H. B. ROBINSON STEAM ELECTRIC PLANT, UNIT NO. 2
DOCKET NO. 50-261/LICENSE NO. DPR-23

SUPPLEMENTAL INFORMATION FOR
REQUEST FOR TECHNICAL SPECIFICATIONS CHANGE
REGARDING STEAM GENERATOR ALTERNATE REPAIR CRITERIA

**LTR-SGMP-09-108 NP-Attachment
Response to NRC Request for Additional Information on H*;
Model 44F and Model 51F Steam Generators
August 27, 2009**

**Response to
NRC Request for Additional Information on H*;
Model 44F and Model 51F Steam Generators**

**Figure RAI4-2
Unit Cell Model and Loading Sequence**

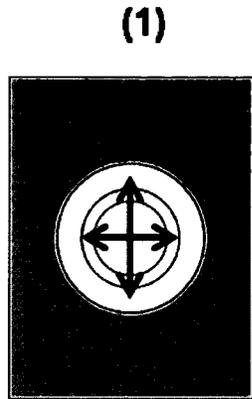
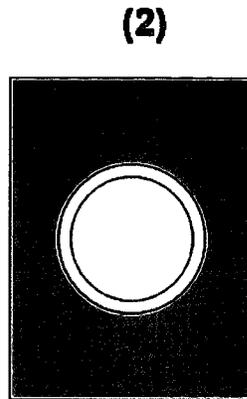
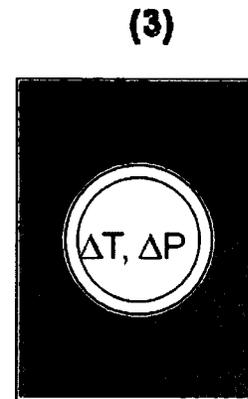
Resolve the apparent inconsistency between Item 4 on page 25 and the statement below Figure RAI4-1 regarding how the model in Figure RAI4-1 is loaded.

The “Unit Cell” model is extensively discussed in Section 6.2.5 of the H* WCAPs (References 5 and 6). The specific goal of this model was to determine if tube to tube contact would remain when the tubesheet is deformed due to operating loads. An equivalent tubesheet cell is modeled, that is, a tubesheet bore with surrounding tubesheet material, and a tube in the tubesheet bore (see Figure 6-48 of the H* WCAPs). For the primary purpose of this model – to study if tube-to-tubesheet contact is present during the limiting tubesheet deformations – the model was initialized by simulating the tube expansion process. The expansion process was conservatively simulated by applying a low value of expansion pressure []^{a,c,e} inside the tube, resulting in initial tube to tubesheet contact, and then removing the tube expansion internal pressure. The calculated dilation of the tubesheet bore due to the simulation of the tube expansion is []^{a,c,e} inch for all models of SG considered.

As discussed in Section 6.2.5 of the H* WCAP reports, the operating pressure loads, were applied to the initialized model in a sequential manner, and the resulting contact pressures were calculated when a range of displacements (termed “E-bar”) were applied as boundary conditions to the model. Figure RAI4-2 shows the updated sequential loading (includes application of thermal loads) of the model and relates it to the steps discussed in Section 6.2.5 and Tables 6-18 and 6-19 of the H* WCAPs. The “E-bar” values shown as the displacement inputs on Tables 6-18 and 6-19 in the H* WCAP reports are uni-directional displacements (in inches) that are NOT the same as eccentricity and also not the same as ΔD . (Eccentricity is defined as the difference between the maximum and minimum diameters of a bore divided by the nominal diameter of the bore. The units of eccentricity are inch/inch.) The displacement inputs applied to the unit cell model are assumed values that based on prior analyses that envelope the expected tubesheet displacement for all of the applicable operating conditions. It is important to note that the unit cell model as described in Section 6.2.5 of the H* WCAP reports utilizes boundary conditions chosen to minimize the tube-to-tubesheet contact pressures for the applied relative displacements.
